DART AEROSPACE LTD	Work Order:	23730
Description: Bracket	Part Number:	D3199-1
TT 05.07.04		
Dwg: D3199 Rev. A1	Qty:	97 100
Ref:		Page 1 of 1

DESIGN <i>CP</i>	DRAWN BY <i>CP</i>	DART AEROSPACE LTD HAWKESBURY, ONTARIO, CANADA		
CHECKED <i>✓</i>	APPROVED <i>✓</i>	DRAWING NO. D3199	REV. A	SHEET 1 OF 1
DATE 03.08.05	TITLE BRACKET	SCALE 1:2		
A	03.08.05	NEW ISSUE		
A1	04.03.01 <i>CP</i>	Z-24 WAS Z-142

D3199-1 BRACKET

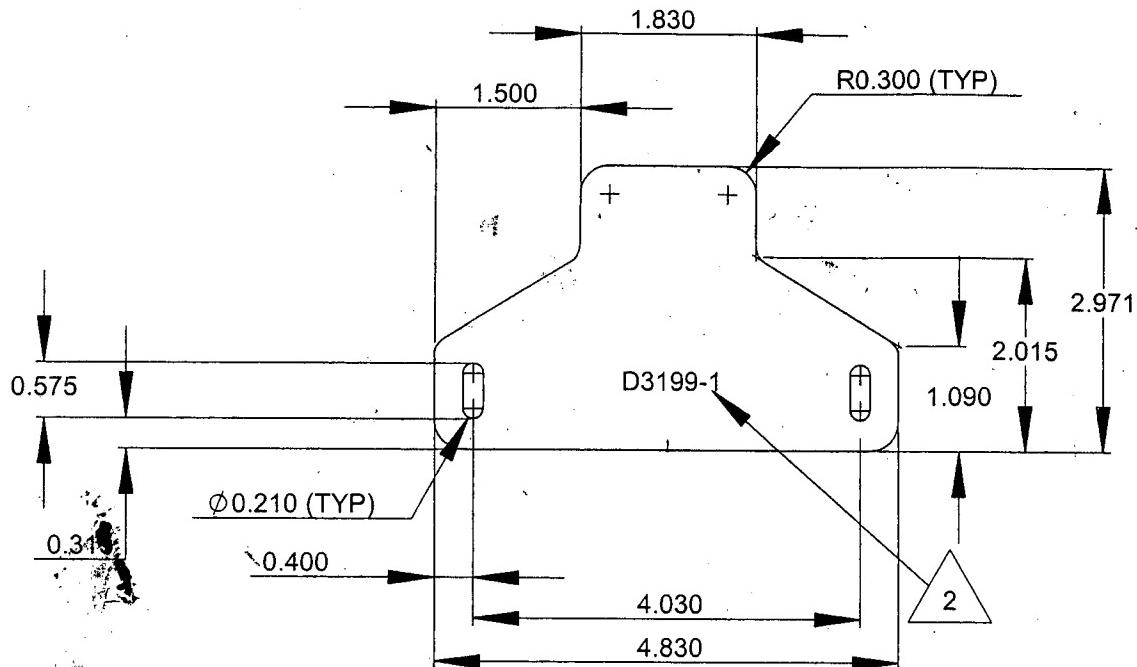
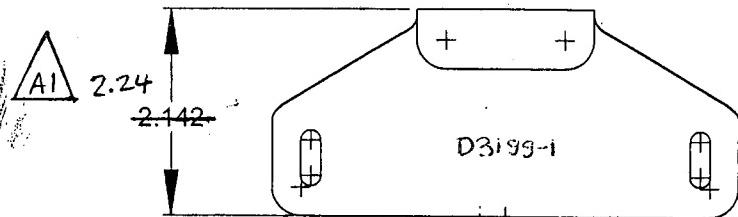
W/O:		WORK ORDER CHANGES						
DATE	STEP	PROCEDURE CHANGE	By	Date	Qty	Approval Mfg / Design Mgr	Approval QC Inspector	
05/09/13	6	The measure .409 change to $.40 \pm .030$ as per attached E-mail.	SB	05/09/13		VB 05/09/13	J 05-05-14	
05-09-14	7	Part number is scribed on clamping fixture cut process, eliminate step 7. <u>Permanent change</u>				VB 05/09/14	J 05-05-14

NCR:		WORK ORDER NON-CONFORMANCE (NCR)						
DATE	STEP	Description of NC Section A	Corrective Action Section B			Verification Section C	Approval Design Mgr	Approval QC Inspector
			Initial Design Mgr	Action Description Design Mgr	Sign & Date			
05-09-08	4	Parts are 0.020" under vertical measurement of 2.971".	AB 05-09-08	final bend dimensions are good. parts Accepted.	AB 05-09-08	J 05-09-08	AB 05-09-08	J 05-09-08
05-09-14	6	1 part scrapped. die damage on part.	AB 05-09-14	Scrap. destroy	J 05-09-14	J 05-09-14	AB 05-09-14	J 05-09-14

With respect to the 0.409 dimension, +/- 0.030 tolerance is acceptable for this batch.
